# Access Compliance Report

## Public Rights-of-Way

Intersection ID: 11691	Main Street: E_18TH_ST	Cross Street: N_MCDOWELL_ST	Location: W
ADA ID: 4E77079476D2	Ramp Type: PerpDiag	Initial Pass/Fail: Fail	Overall Compliance: No
		Severity Score: 35

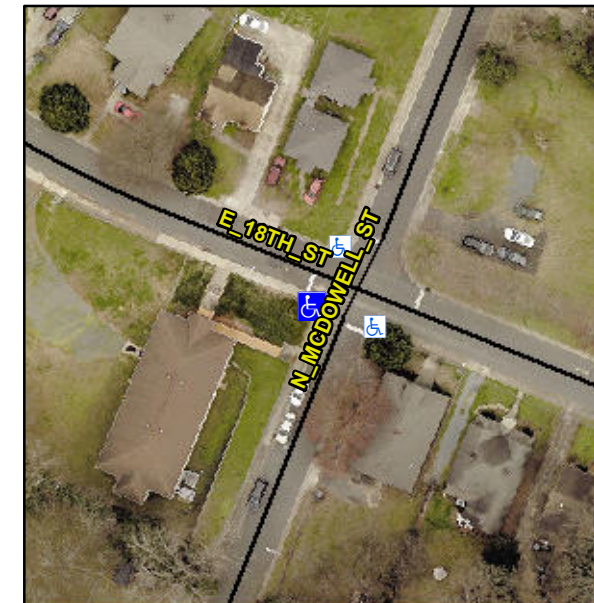
**R304.5.1, R304.2.2, R304.5.3**

Compliance	Description	Data	Compliance	Description	Data
N/A	Ramp Length (in)	62.0	No	Ramp Slope (%)	12.2
No	Ramp Width (in)	47.5	No	Ramp XSlope (%)	4.6
N/A	Flare Type LT	N/A	N/A	Flare Type RT	N/A
N/A	Flare Slope LT (%)	N/A	N/A	Flare Slope RT (%)	N/A
N/A	Flare Traversable LT?	N/A	N/A	Flare Traversable RT?	N/A
N/A	Landing Length (in)	N/A	N/A	DWS Provided?	N/A
N/A	Landing Width (in)	N/A	N/A	DWS Contrast?	N/A
N/A	Landing Slope (%)	N/A	N/A	DWS Length (in)	N/A
N/A	Landing X Slope (%)	N/A	N/A	DWS Full Width?	N/A
N/A	Landing Curb? (Y/N)	N/A	N/A	DWS Offset (in)	N/A
N/A	Shared Landing?	N/A			
N/A	Gutter Ponding?	N/A	N/A	Gutter Slope (%)	N/A
N/A	Gutter Lip Ht (in)	N/A	N/A	Gutter X Slope (%)	N/A
N/A	Painted X Walk1?	No	N/A	Painted X Walk2?	No
	X Walk 1 Direction	To SE		X Walk 2 Direction	To NE
N/A	X Walk 1 Width (in)	N/A	N/A	X Walk 2 Width (in)	N/A
	X Walk 1 Slope (%)	7.4		X Walk 2 Slope (%)	1.1
	X Walk 1 X Slope (%)	0.7		X Walk 2 X Slope (%)	6.7

**Remove & Replace Curb Ramp With Two New Directional Ramps or Equivalent.**
